May 21, 2019 - amended and resubmitted 5/31/19

RE: MPUDFY2019-1

PROJECT NAME:
 S & S Townhomes
 Sue Samson
 322 E. 44th St. Garden City, ID 83714

1 Site NEW
 1/8" = 1'-0"

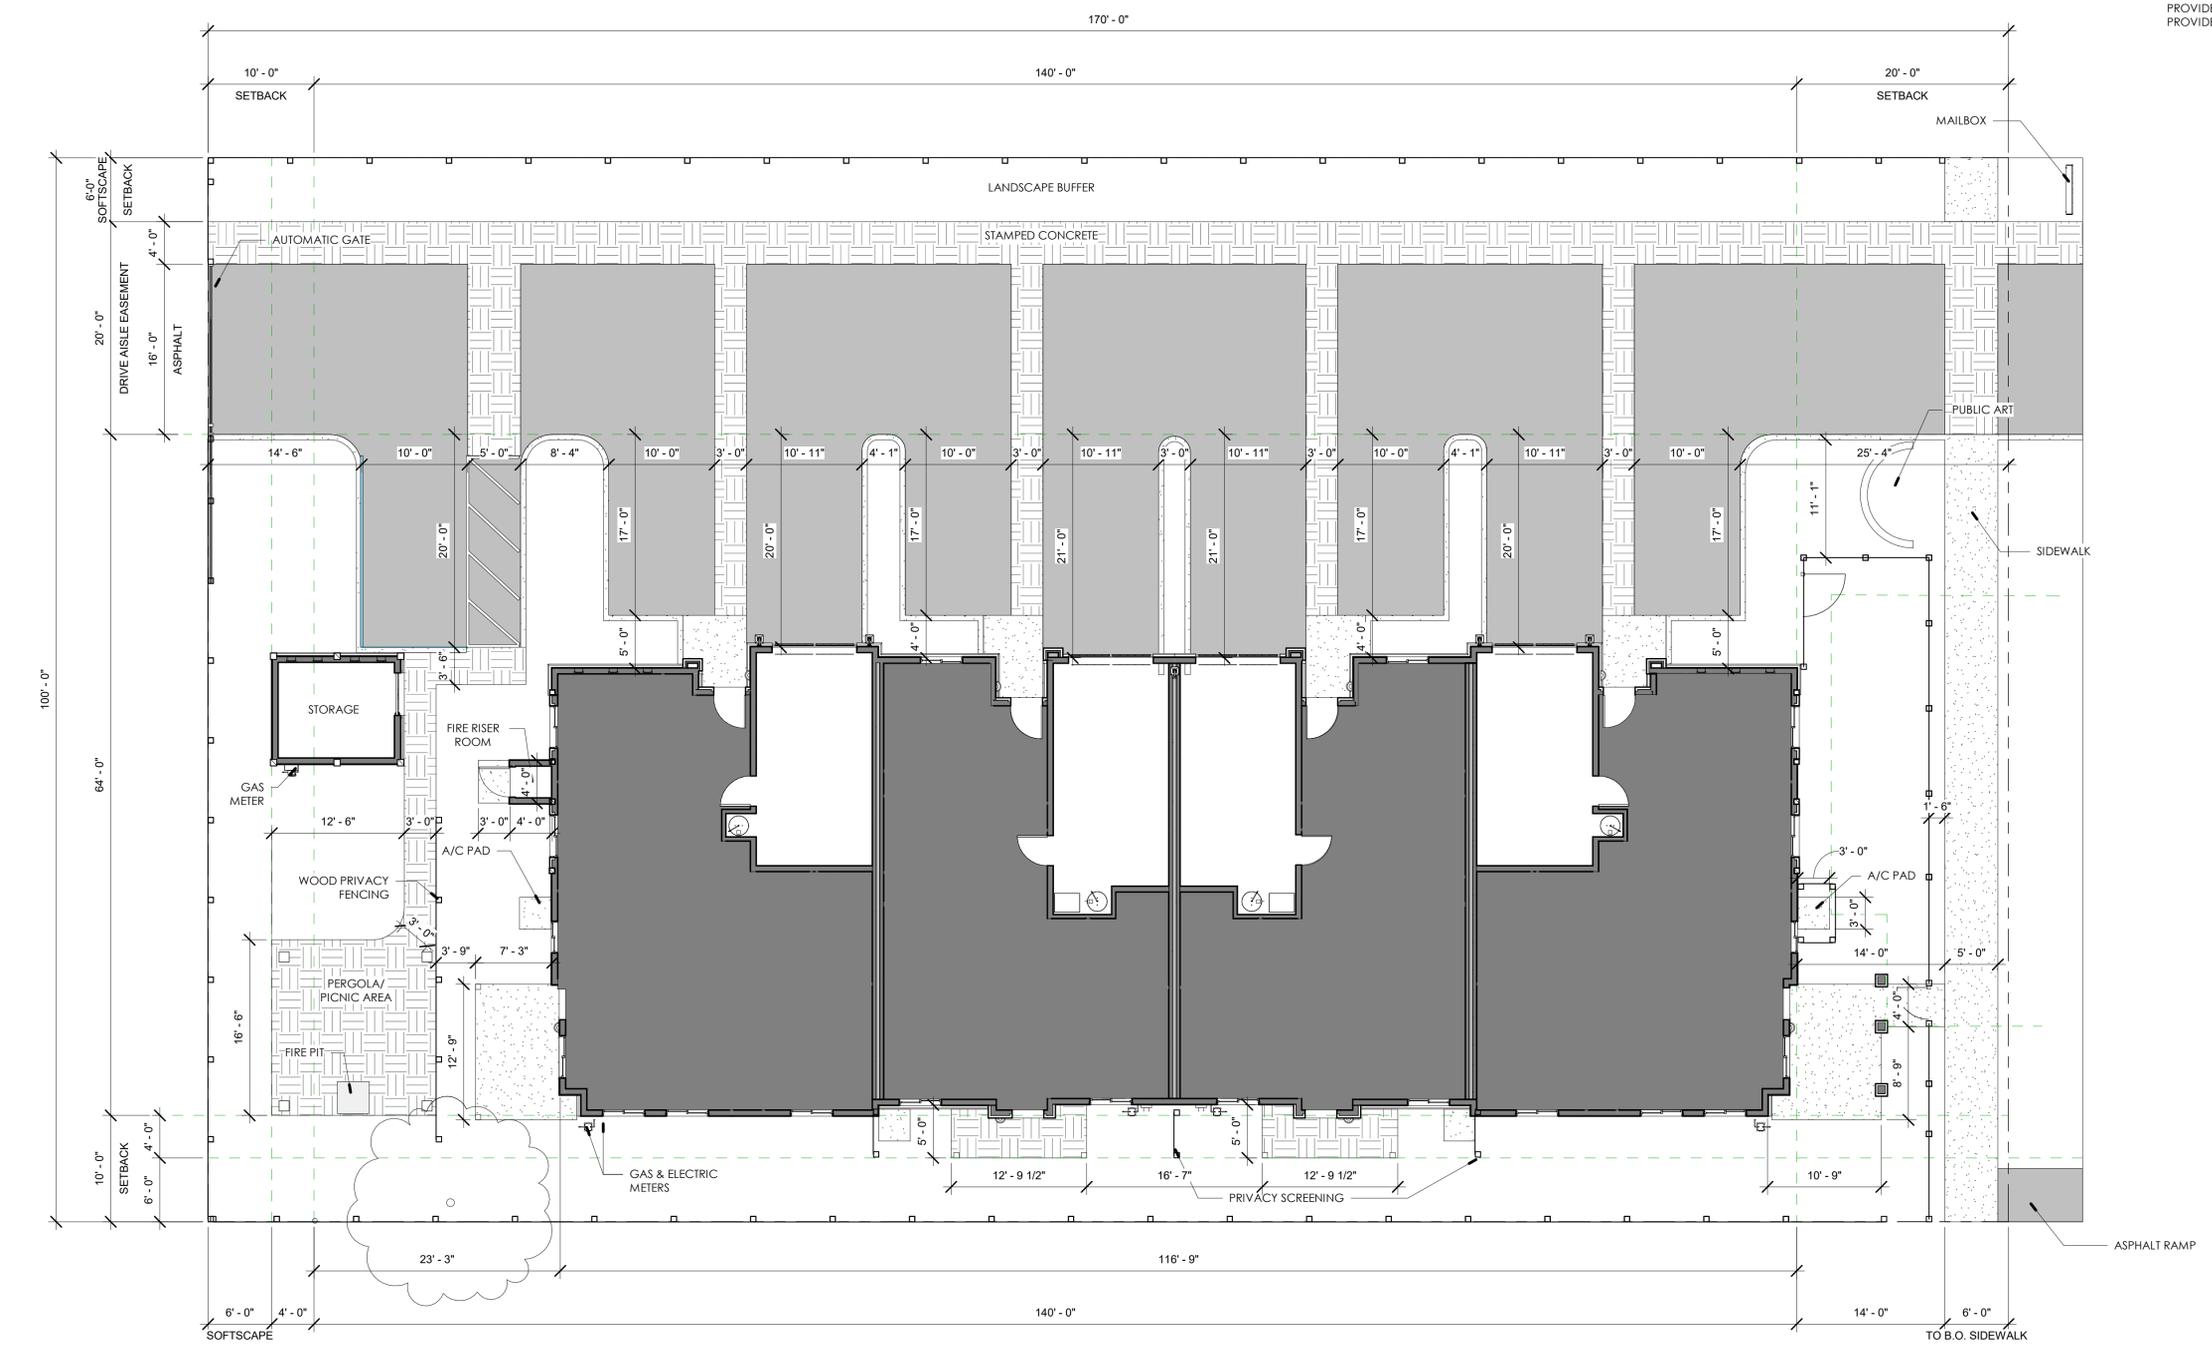
1. **RISER ROOM ADDED** -The plans reviewer with the state of Idaho has indicated that we may need to provide a fire sprinkler system for the fourplex. This requires the addition of a riser room. We have added a 4 x 4 riser room on the west side of the building and a required stoop outside the door to that room. At this point, we are not certain that sprinkler will be required. We are requesting that this be approved as an option because the answers that we get when this question is asked vary.

2. **GARAGES SLIGHTLY ENLARGED**- The garages in the 2 bedroom units have been lengthened by 2' each using some of the extra driveway space in front of the garages. This caused 6 square feet of landscape and 42 sq ft of hardscape to be used for garage. The change in landscape square footage is slight, so we will just adjust the location of the plants slightly. The garages in the 3 bedroom units were also lengthened by 1' each. This space was taken from the rear of the 3 bedroom units and in the process 24' sq ft of landscape was converted to the interior of the building. The plants for that location will still be planted, just slightly adjusting their location. In addition, we have added several landscape plants (see 10 below) to compensate.

5. **FENCE MOVED** -The metal fence along the ACHD right of way and the sidewalk has been moved to 1 ½ feet from the sidewalk, providing adequate space for passersby to use the sidewalk (shy space) but including more of the front yard inside of the fence. The north-south length of fence leading to the public art display was shortened by around 1-1/2 feet and the location of the gate to the front yard was adjusted. This created additional space inside the yard for landscaping, so two additional plants (lavender lady lilac) were added between the egress window and the sidewalk for privacy and aesthetics.

6. **CURB REDUCED/ENTRY ENHANCED** -The curbing near the front doors of the apartments has been moved back a little to provide easier access to the front door, a more clearly defined entrance, and less of a trip hazard near the door. This change slightly reduced the size of the planter bed by the front door. The plants removed (2 bowles golden sedge) were moved to the south side of the building.

9. **EXTEND PATIO COVERS** -The roofs of the three patio covers and the picnic area will need to extend 1-2 feet past the posts (the way the pieces fit together, there needs to be an overhang). For the 2 bedroom apartments this will cause the roof to extend toward the shrub space. The posts will not move. The posts will still be at the approved spot from the original approved MPUD application. It is only the overhead covers themselves that will need to extend past the posts. This will not affect the landscaping underneath the covers and no space on the ground will be changed. We believe this is not a significant change but we did add some additional landscape plantings on the west side of the property to make sure landscaping remained adequate (see 10 below).

5 Landscape Plan
1/8" = 1'-0"

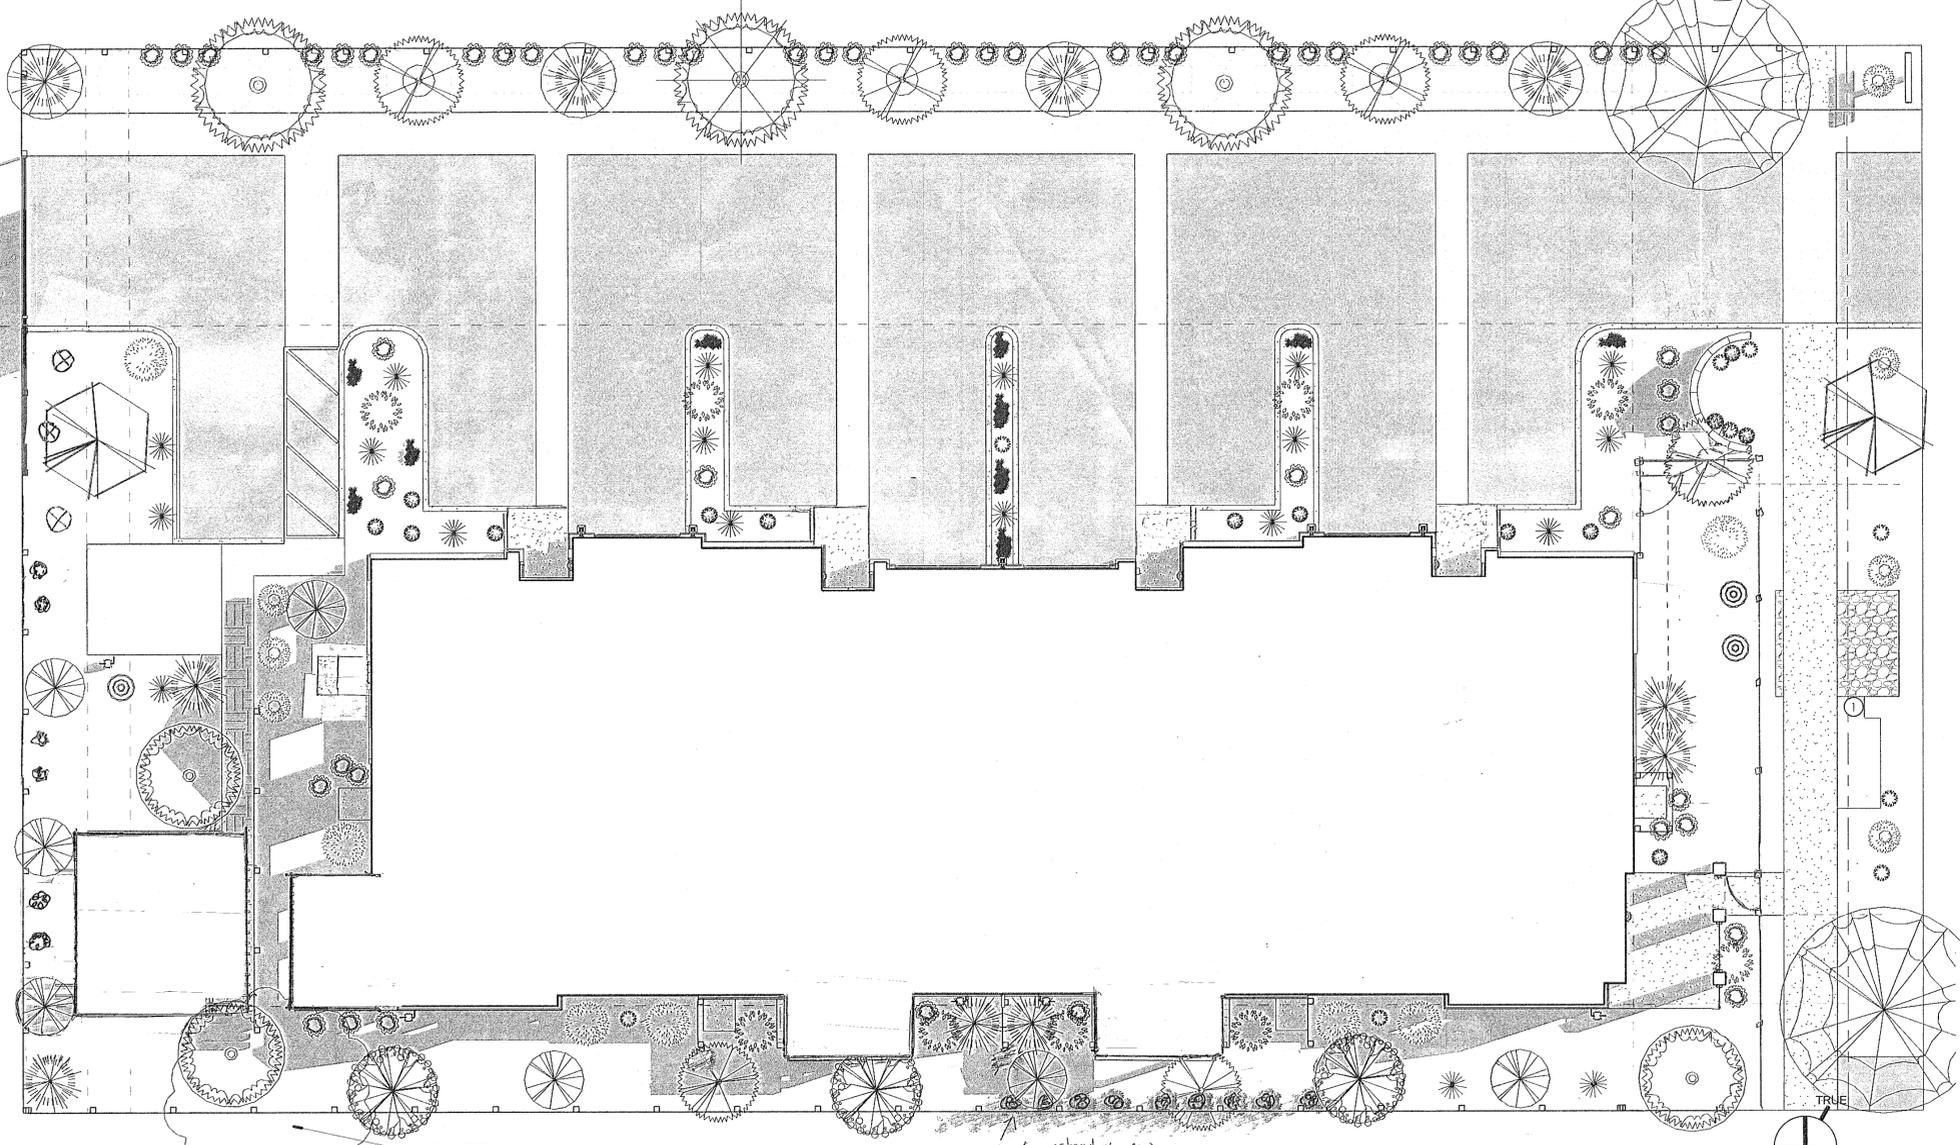
7. **PLANT TYPES/LOCATIONS CHANGED** -Certain areas of the yard need hedging to screen the building from neighboring properties. The plants on the south side of the building were changed from Hicks Yew to Thuja because the newer choice was more suitable for creating a tall hedge. Also, two of those plants were moved to the west edge of the property to help screen the fourplex from the neighbor to the west. We are requesting flexibility in the placement/variety of these plants so that the contractor can provide the most effective screening possible.

10. **LANDSCAPE PLANTS ADDED** - There were some plants added on the west side of the property to provide additional screening from the neighboring property. We added 6 Thuja plants of 2 different kinds in areas of the landscape that did not already provide screening. We are requesting flexibility in the placement/variety of these plants so that the contractor can provide the most effective screening possible.

SHEET NUMBER:
A.211
 PLOT DATE: 5/31/2019 2:25:19 PM

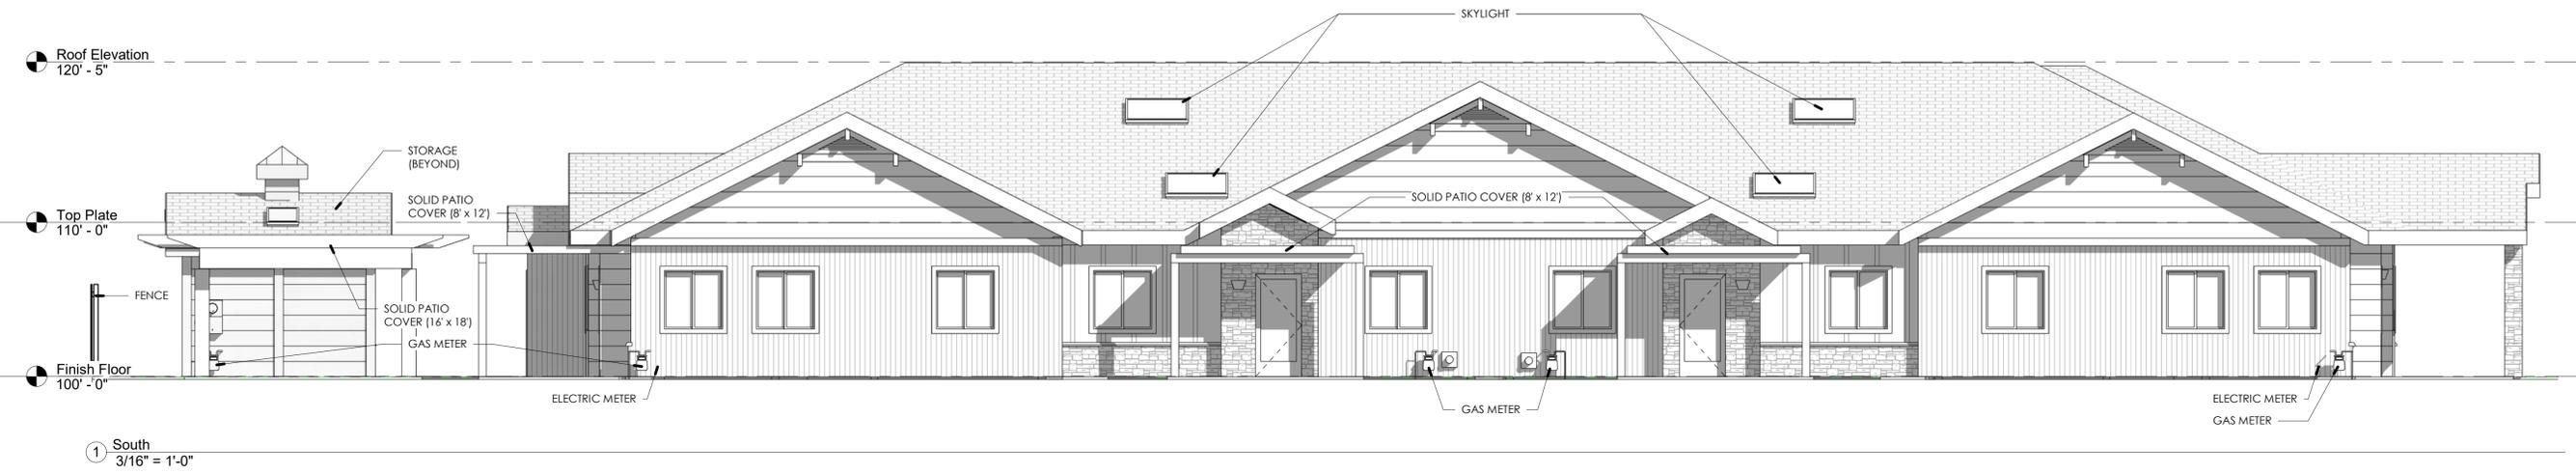
4. **TRADE LOCATIONS OF SOME WINDOWS ON UNIT D**-There is an egress window shown on the north face of the east unit and 2 of the decorative windows on the east face of the same unit (bordering 44th street). They both serve the same bedroom in that first unit. We would like to switch them around. That would mean the egress window would be on the east face (inside the yard, facing 44th street) and the 2 decorative windows (plus one additional window added for symmetry), would be on the north face (looking out on the driveway).
